CITY OF ALBUQUERQUE

RE: 3401 Calle Facio NW
Revised Grading and Drainage Plan
Engineer's Stamp Date: 12/14/20
Engineer's Certification Date: 04/01/21
Hydrology File: H12D003B

Based upon the information provided in your submittal received 04/01/2021 and site photos sent on 4/2/21, the Grading and Drainage Plan is approved for Building Permit and Building Pad Certification for 3401 Calle Facio NW. Please attach a copy of this approved plan in the construction sets for Building Permit processing along with a copy of this letter.

12/14/20 DAVID SOULE P.E. #14522	3401 CALLE FACIO	DRAWN BY: WCVJ
	GRADING AND DRAINAGE PLAN	DATE: 11-16-20
	 1606 CENTRAL AVENUE SE SUITE 201 ALBUQUERQUE, NM 87106 (505) 872-5999	2102098--LAYOUT--11-16-20
		SHEET #
		JOB # 2102098

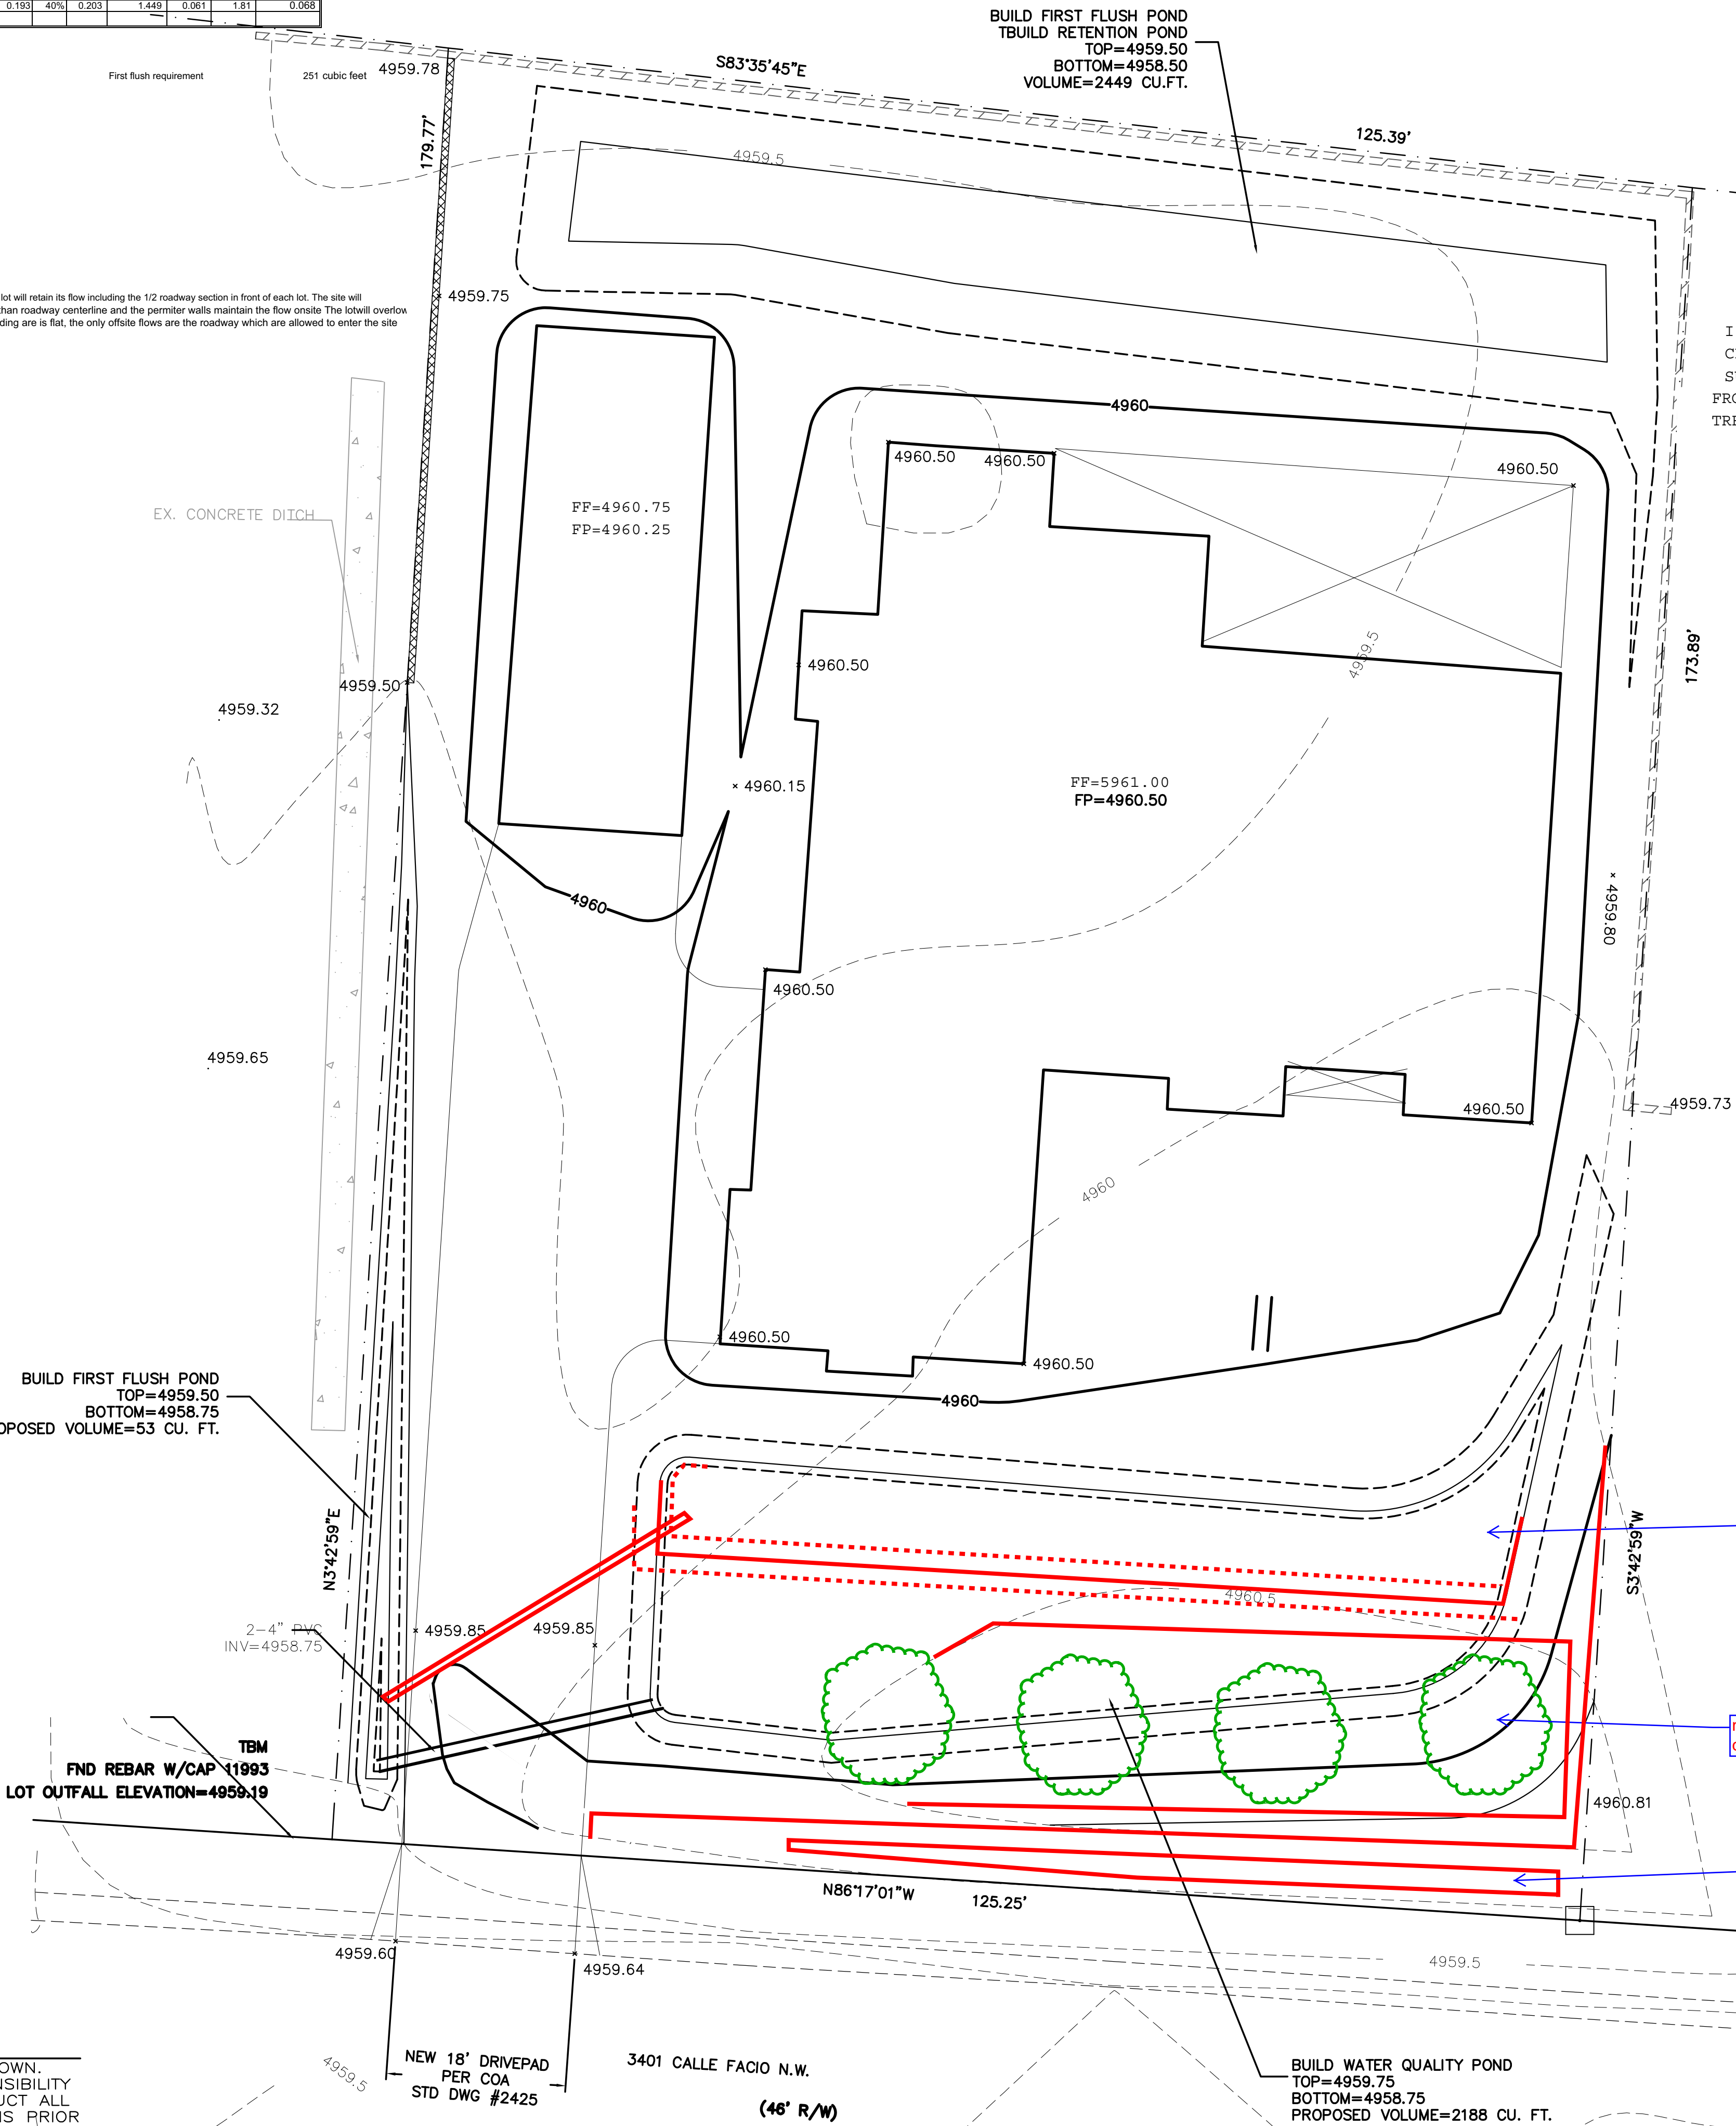
Prior to approval in support of Permanent Release of Occupancy by Hydrology, Engineer Certification per the DPM checklist will be required.
